Supplement to the proposal for 03 series of amendments to Regulation No. 95

The text reproduced below was prepared by the expert from France in order to extend the scope of the present Regulation to all kinds of power train systems above a certain working voltage level. The modifications to the existing text of the Regulation R 95 are based on informal document No. GRSP- 46-04, distributed during the forty sixth session of the Working Party on Passive Safety (GRSP) and discussions made at the 3rd EVPC adhoc group meeting held in Bonn, 11-12 march 2010, respectively. This informal document supersedes document ECE/TRANS/WP.29/GRSP/2010/21 distributed as an official document for the forty-seventh session of the Working Party on Passive Safety (GRSP). The modifications to the existing text of Regulation No. 95 are originally marked in bold or strikethrough characters and the modifications resulting from the EVPC meeting are highlighted in grey colour.

Figure 1: Measurement of Vb, V1, V2, V3

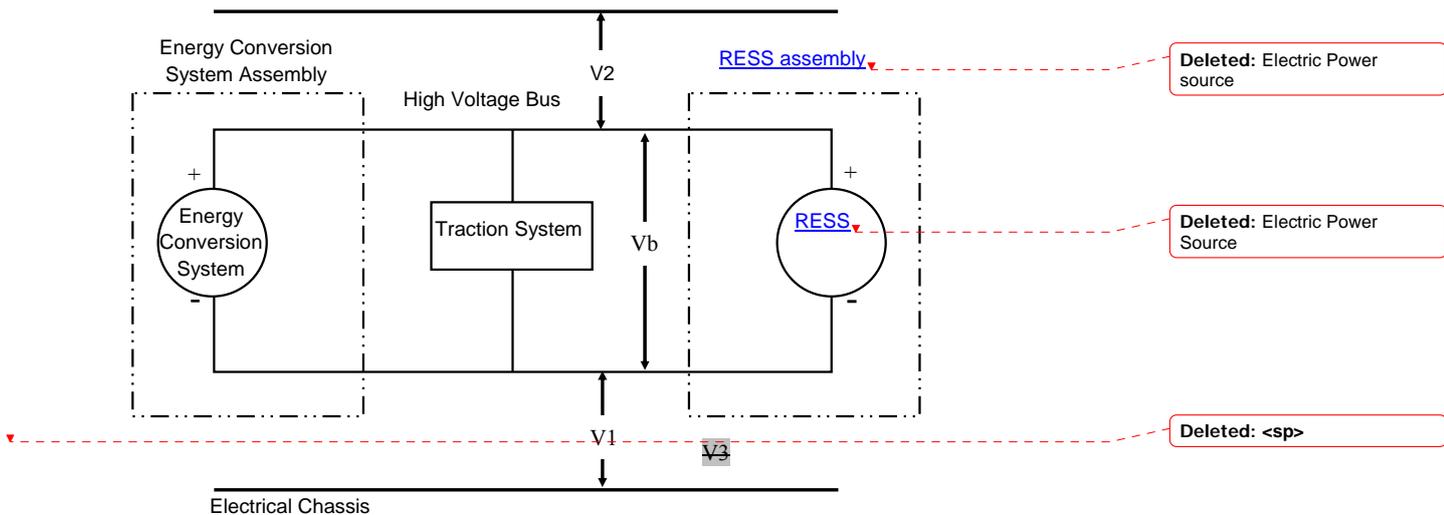
Before the vehicle ~~impact-crash test conducted,~~ ~~measure and record~~ the high voltage bus voltage (Vb) (see figure 1) shall be measured and recorded to ~~and confirm that it is~~ within the operating voltage of the vehicle as ~~defined~~ specified by the vehicle manufacturer.

After the impact crash test, determine the high voltage bus voltages (Vb, V1, V2) (see figure 1). If the RESS has exposed conductive parts, measure the voltage V3 between any exposed conductive parts of it and the electrical chassis.

The voltage measurement shall be made not earlier than 5 seconds, but, not later than 60 seconds after the impact.

Figure 2: E.g. Measurement of high voltage bus energy stored in X-capacitors

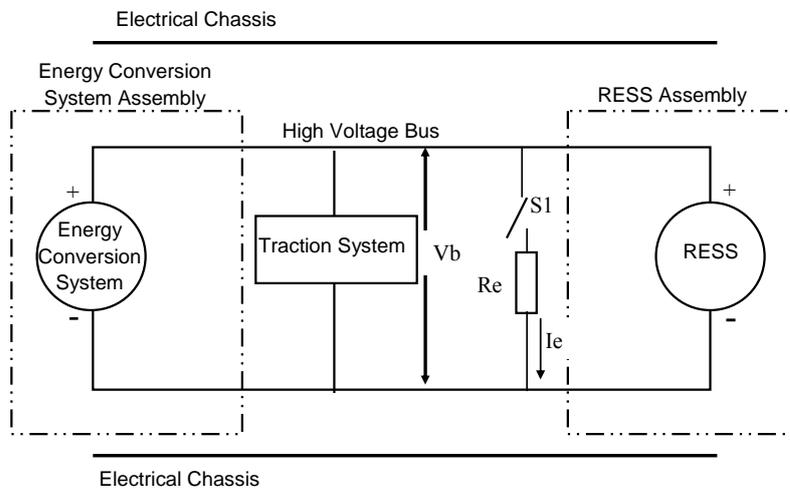
Prior to the impact a switch S1 and a known discharge resistor Re is connected in parallel to the relevant capacitance (ref. figure 2), installed according to figure 2.

Not earlier than 5 seconds and not later than 60 seconds after the impact the switch S1 shall be closed while the voltage Vb and the current Ie are measured and recorded. The product of the voltage Vb and the current Ie shall be integrated over the period of time, starting from the moment when the switch S1 is closed (tc) until the voltage Vb falls below the high voltage threshold of 30 V AC or 60 V DC (th). The resulting integration equals in the total energy (TE) in joules.

Figure 1: Jointed test finger

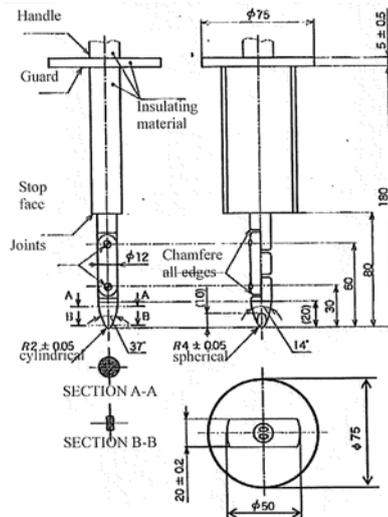
The Jointed Test Finger ~~access probe~~ described in Appendix 1 figure 1 ~~is pushed against~~ shall be inserted into any gaps or openings of the ~~original~~ physical protection with a ~~the~~ test force of $10\text{ N} \pm 10\text{ per cent}$ for electrical safety assessment. If partial or full penetration ~~it partly or fully penetrates into the original physical protection~~ by the Jointed Test Finger ~~occurs, it is~~ the Jointed Test Finger shall be placed in every ~~possible~~ position as specified below.

The requirements of paragraph 5.3.6.1.3 shall be considered to be met if the Jointed Test Finger ~~access probe~~ described in Appendix 1, figure 1 ~~shall not~~ is unable to contact high voltage ~~touch~~ live parts.
